SECTION 75W MODIFICATION APPLICATION

Concept Plan for Commercial and Retail Development

396 Lane Cove Road and 1 Giffnock Avenue, Macquarie Park

MP 09_0209 MOD 3

Figure 8: Proposed building envelope plan and building separation (Source: Proponent's RtS Addendum Report)

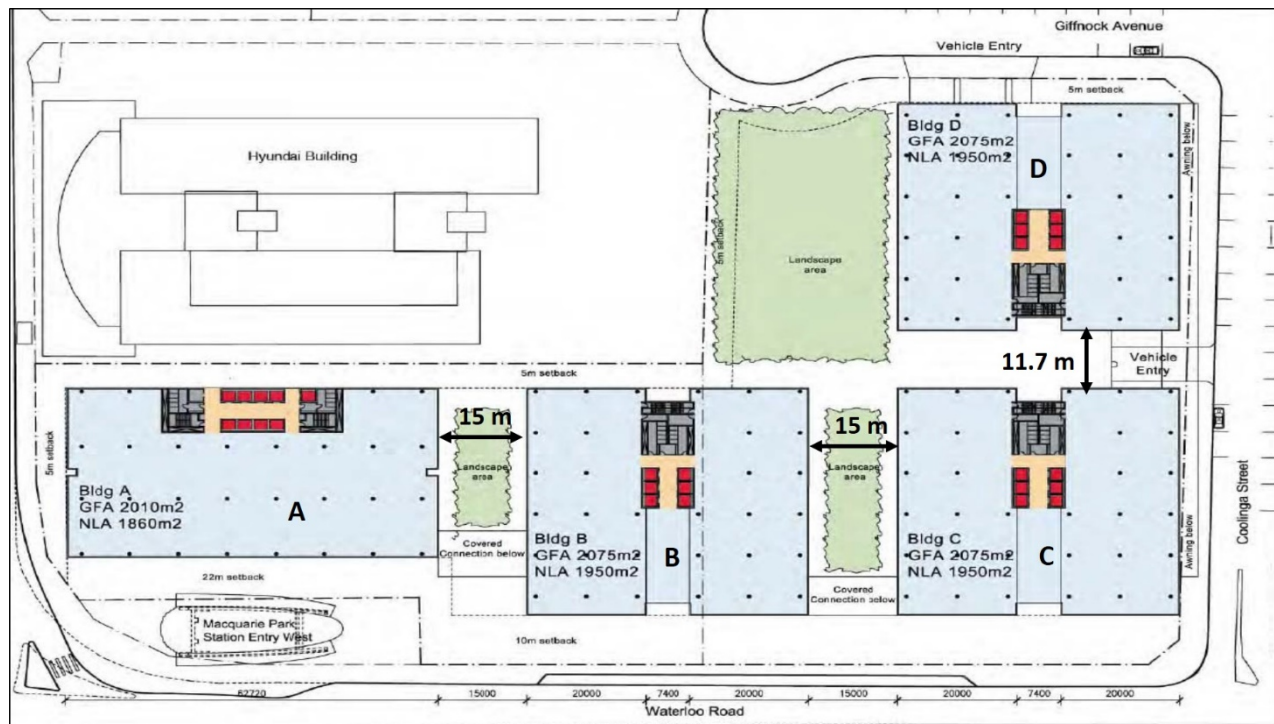
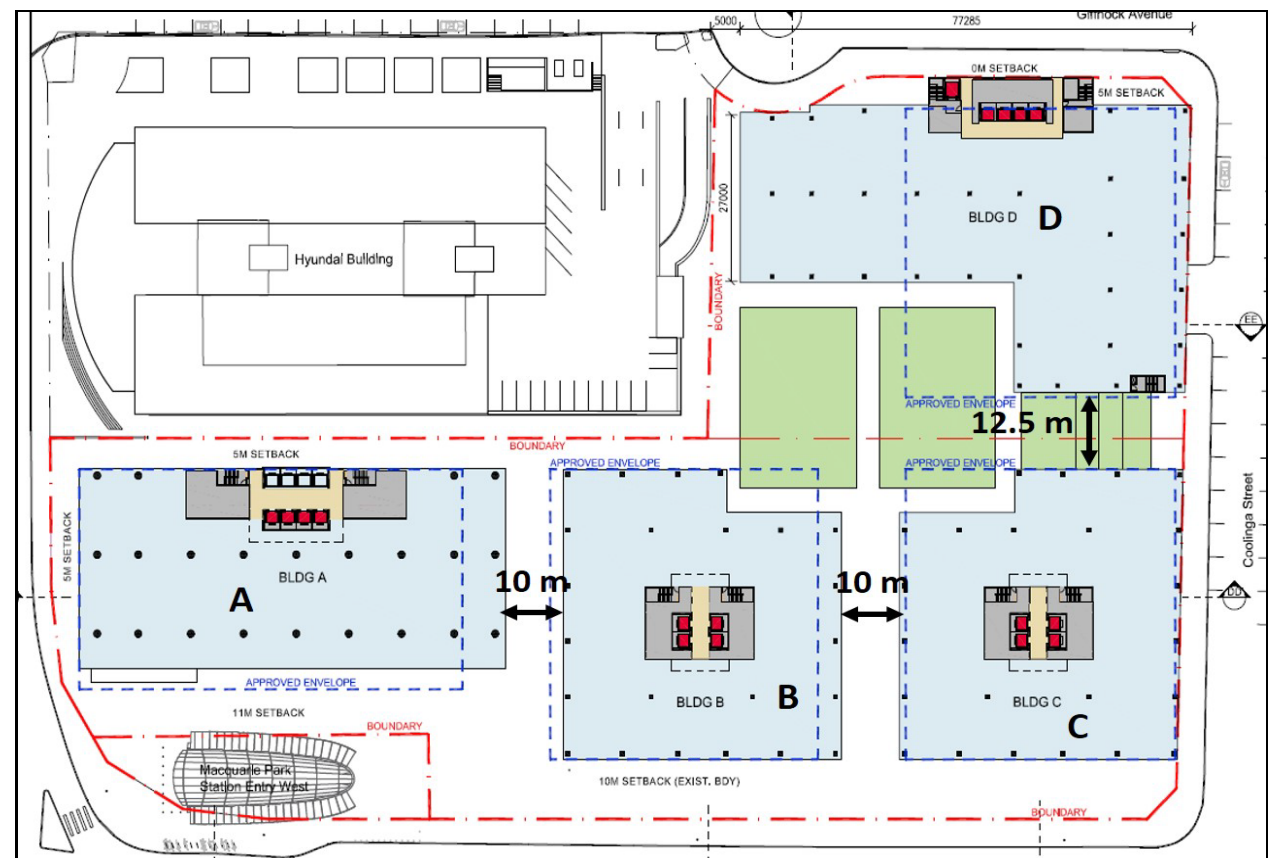
As a result of these changes, building separation between the buildings has changed as outlined in **Table 4**.

Council originally objected to the proposed changes, due to the reduced laneway widths and building separation, loss of physical connectivity and solar access. However, in response to concerns raised by Council, the Proponent has amended the proposal (in the RtS Addendum), which has increased building separation from 9 m to 10 m and 12.5 m (**Table 4**).

The Department has considered the modified building envelopes, including separation, and is satisfied the changes result in a positive outcome for the site. The siting of the four buildings remains largely consistent with the approved building envelopes and while the application reallocates floor area between buildings on the site, the maximum GFA of 83,368 m² and maximum heights of Buildings A – D remains unchanged.

Figure 10: Proposed ground floor plan (retail uses - light yellow, lobby areas - dark yellow) and laneway widths (Source: Proponent's RtS Addendum Report)

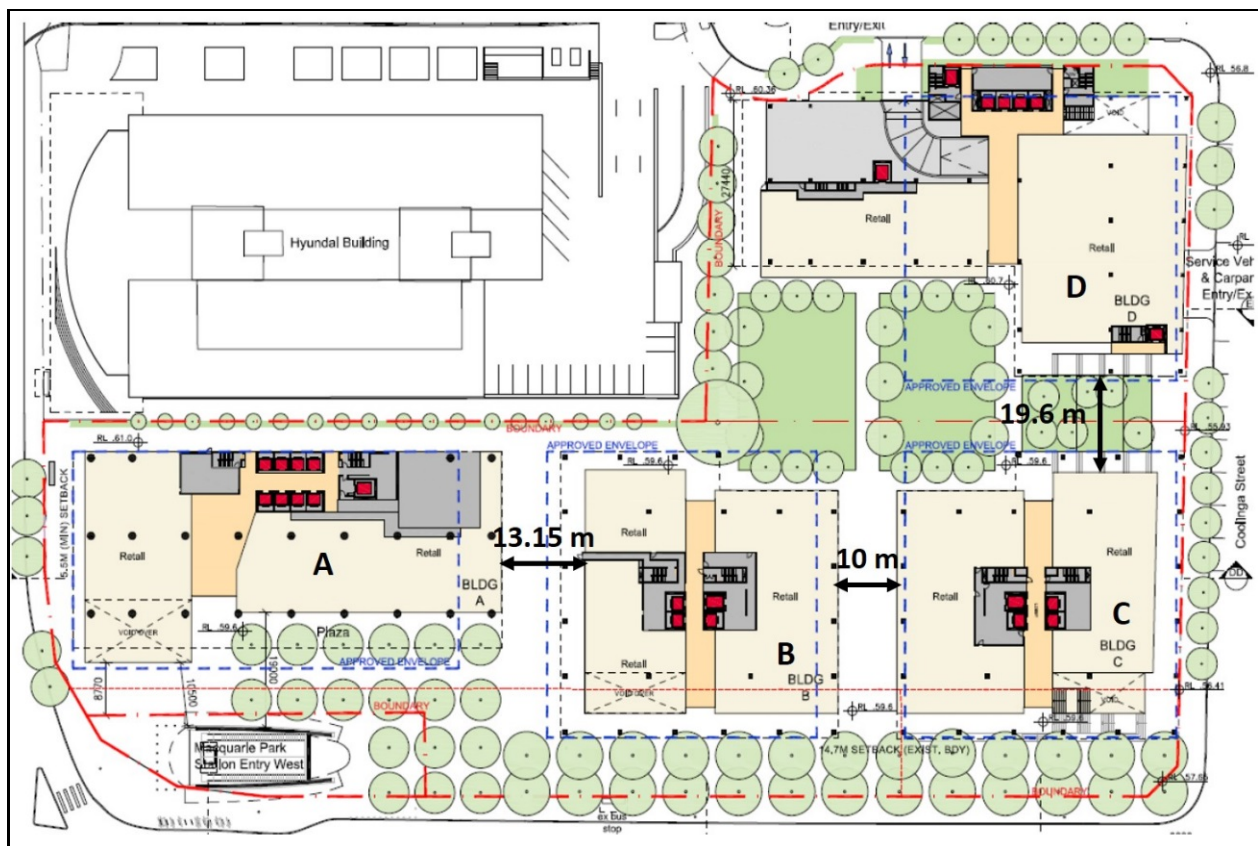
| Issue | Consideration | Recommendation |
|-------------------|---|--|
| Ground floor uses | <ul style="list-style-type: none"> The proposal replaces the ground floor office/ lobby space with lobby and retail uses to active the laneways The Department considers this change is positive as it will contribute to the activation of public domain areas and encourage pedestrians to travel through the site Building lobbies have been positioned to relate to pedestrian movements through the site and link to the public domain areas The Department notes the use of the retail areas will be subject to | The Department considers no additional conditions or amendments are necessary. |

Figure 12: Proposed Building A mass change and Building B location shifted (Source: Proponent's EA Report)

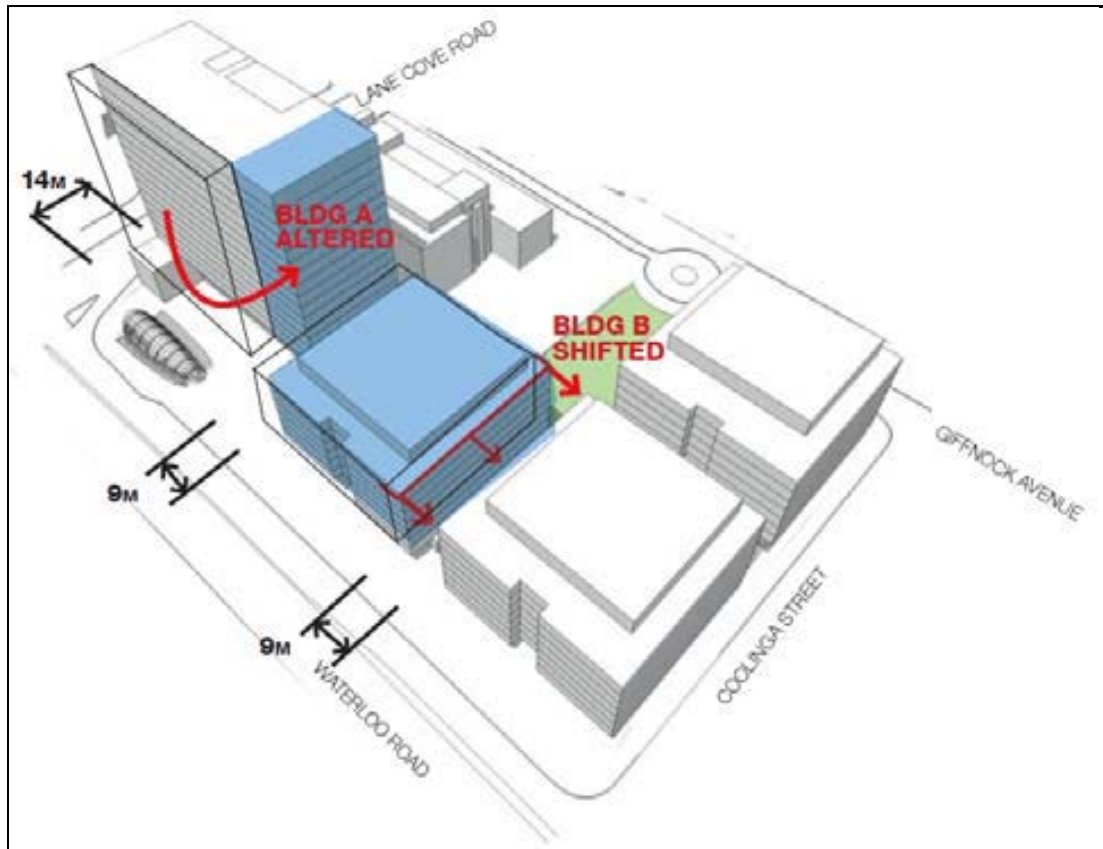
The length of Building A has also been reduced in the RtS Addendum which lessens the bulk and mass of the building as viewed from Waterloo Road and visual breaks are retained between the modified envelopes, which will ensure views and pedestrian connectivity and enhance pedestrian activity, permeability and legibility.

Figure 13: Proposed changes to Building D mass and location of the park (Source: Proponent's EA Report)

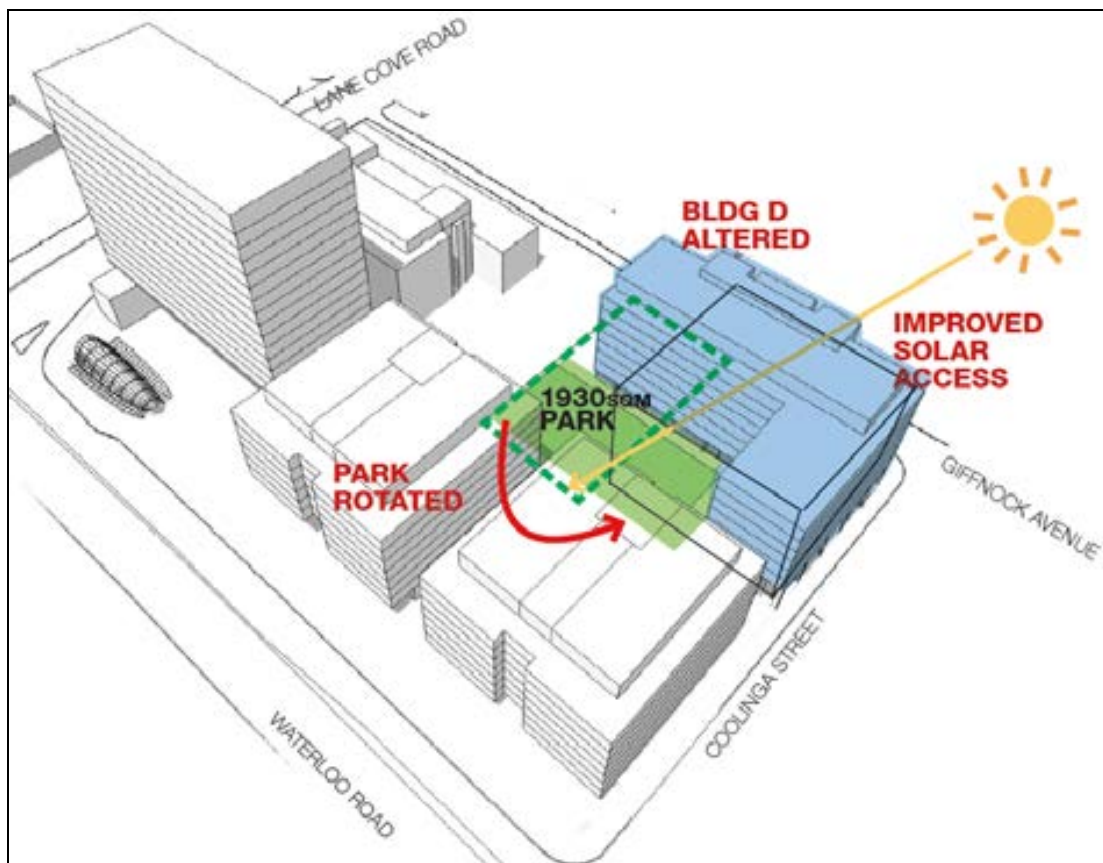
The change to Building D, while resulting in additional building mass/ length to Giffnock Avenue, provides for a wider and safer through site link from Giffnock Avenue to the central park and the station entrance. Landscaping proposed in Giffnock Avenue includes new street trees and mass planted verges to soften the built form in the streetscape.

Figure 15: Final amendments to proposal – Building A mass altered, laneway widths increased, central park extended to Coolinga Street and Building D mass redistributed (Source: Proponent's RtS Addendum Design Report)

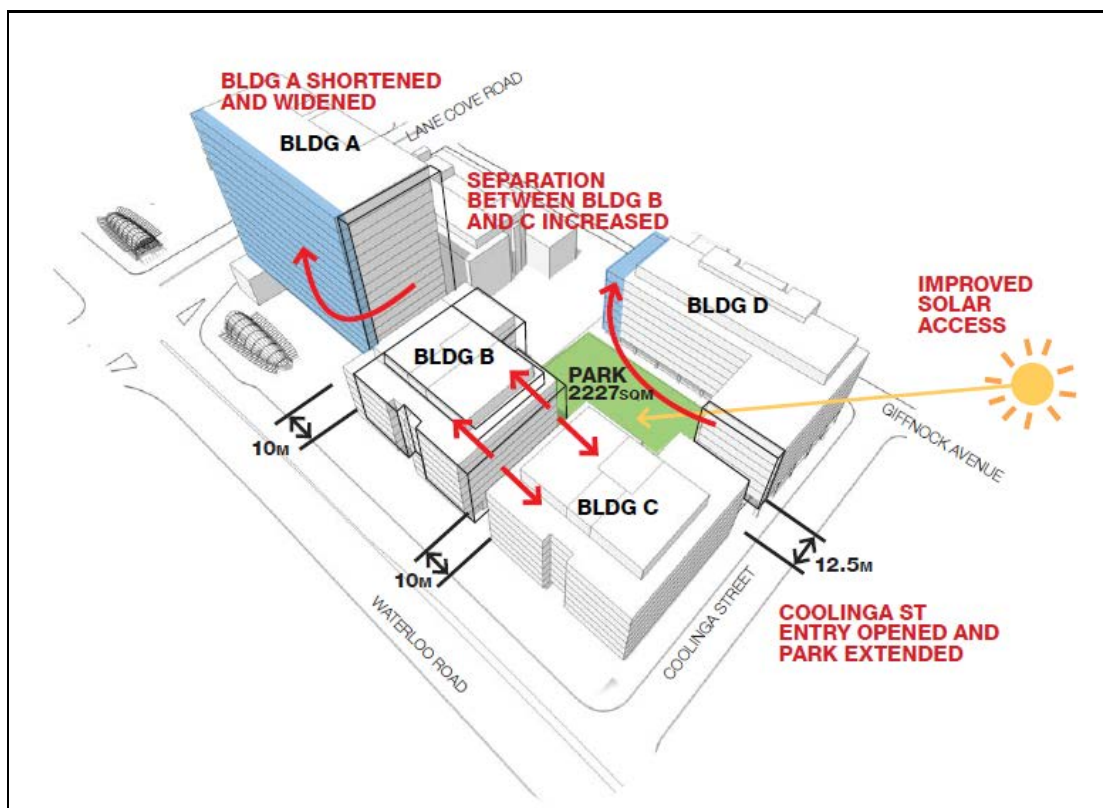
Council has reviewed the RtS Addendum plans and advises that it no longer objects to the proposed changes.

Figure 17: Artist impression of laneways (Source: Proponent's RtS addendum additional information report)

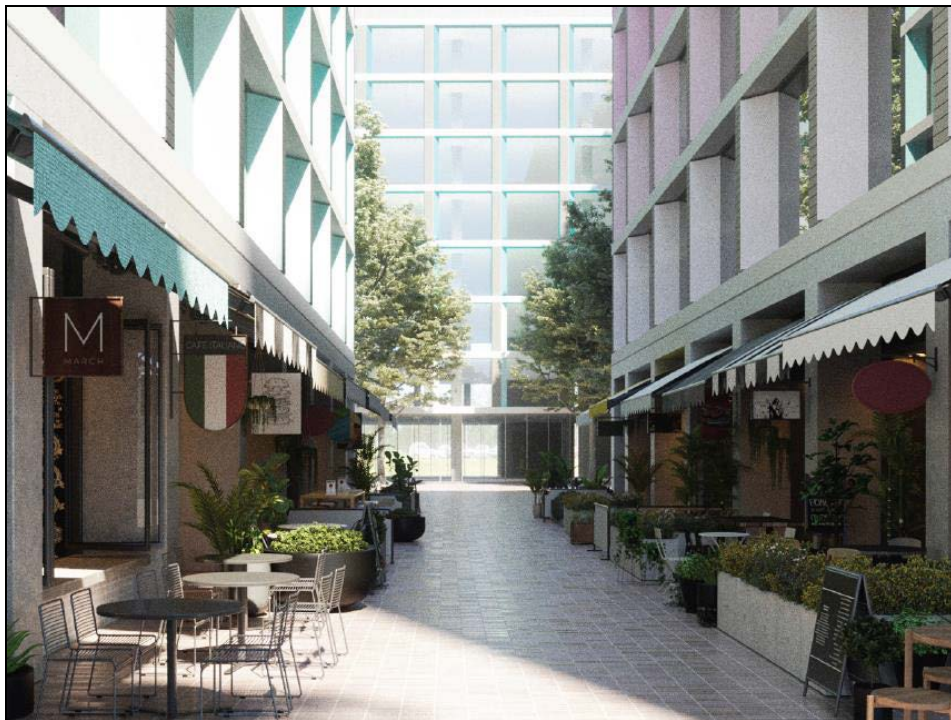
The Department considers the proposed laneway widths are suitable as narrowing the laneway widths from the concept approval will create a more intimate urban environment at street level. The pedestrian capacity study undertaken by the Proponent indicates a good level of space is provided and the laneways are capable of accommodating pedestrian movements through the site.

The Department also notes the laneways generally reflect pedestrian desire lines through the site and continue to provide physical connections and view lines through the site, consistent with the concept approval. The laneways also comply with Council's DCP 2014, requiring pedestrian

The Department concludes the proposed laneway widths are acceptable as the reduction in width result in a larger central park, which receives improved solar access.

Figure 18: Proposed basement levels (outline of approved basement shown in blue) (Source: Proponent's Architectural Plans)

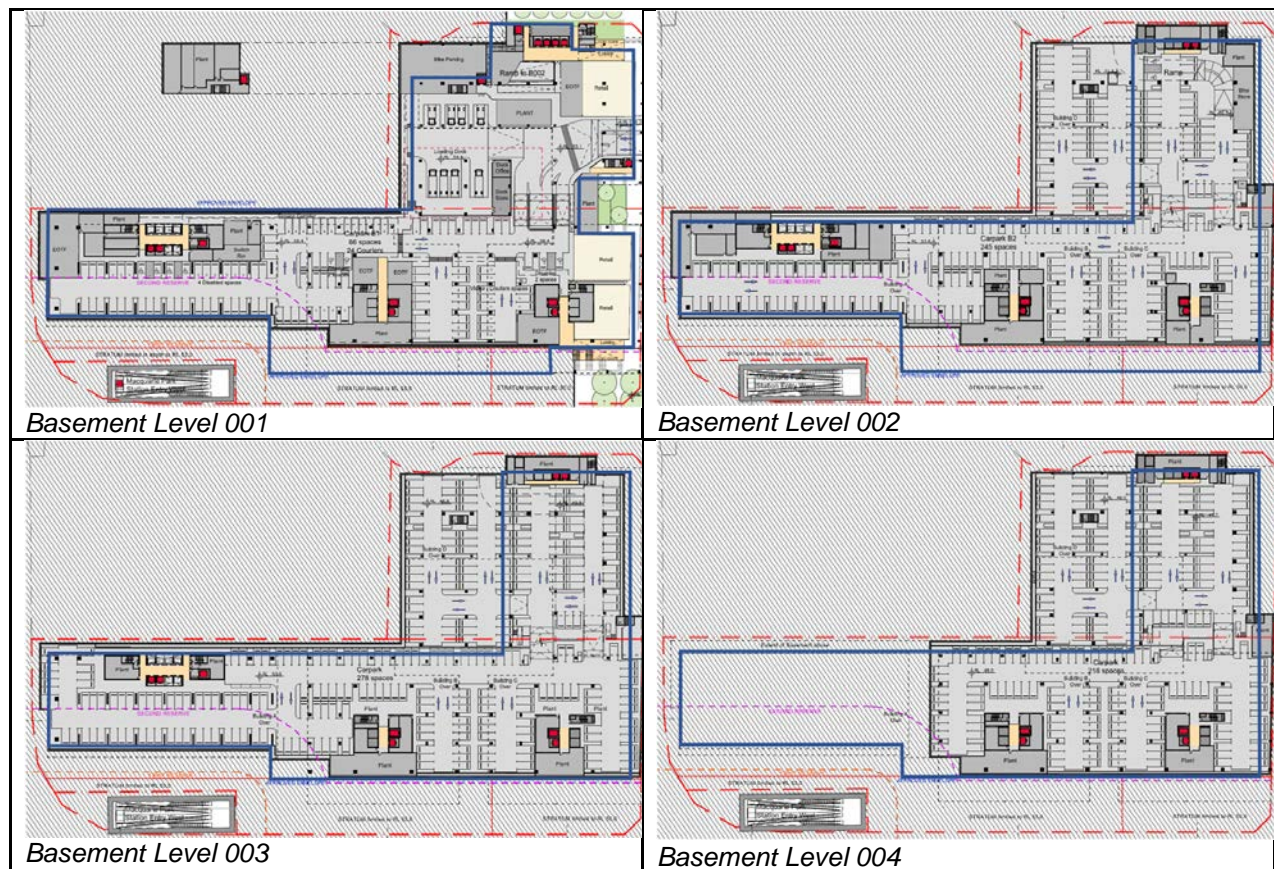
The modified proposal also seeks to reduce the number of basement levels from six to four and amend the footprint of each level (as a result of Condition B1 reducing the number of employee car parking spaces) (**Figure 18**). The Department notes the reduction of basement levels from six to four results in changes to the basement footprint. However, the basement levels remain generally consistent with the footprint of the approved basement levels 001 to 003 and a reduced level 004. The Department also notes the basement levels are now generally positioned away from the existing railway infrastructure and their reduced depth (by two storeys) would have less potential impact on the railway. TfNSW and Sydney Trains raised no concerns about the changes to the basement.

The Department considers the amendments allow for a more efficient use of space as the approved car parking spaces are provided in a reduced number of basement levels.

Figure 20: Proposed pedestrian access off Coolinga Street (Source: Proponent's RtS Addendum Report)

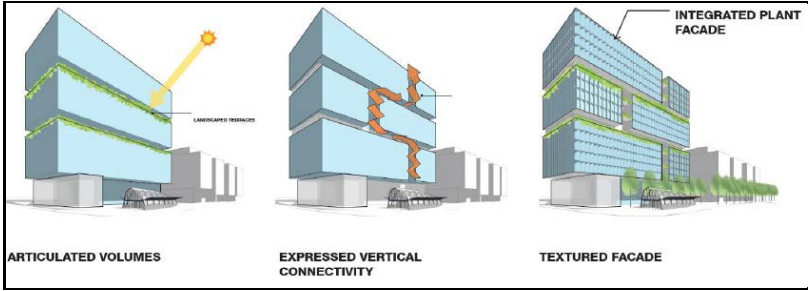
Council and RMS reviewed the proposal and did not make any comments regarding the access arrangements.

The Department considers the access changes provide improved safety by separating vehicle and pedestrian access to the site. The change also allows for a widened pedestrian access from Coolinga Street, as well as a visual connection from the street to the central public park.

The Department also notes the changes to the service vehicle access off Coolinga Street does not result in any changes to the number of car parking spaces or pedestrian access to the site.
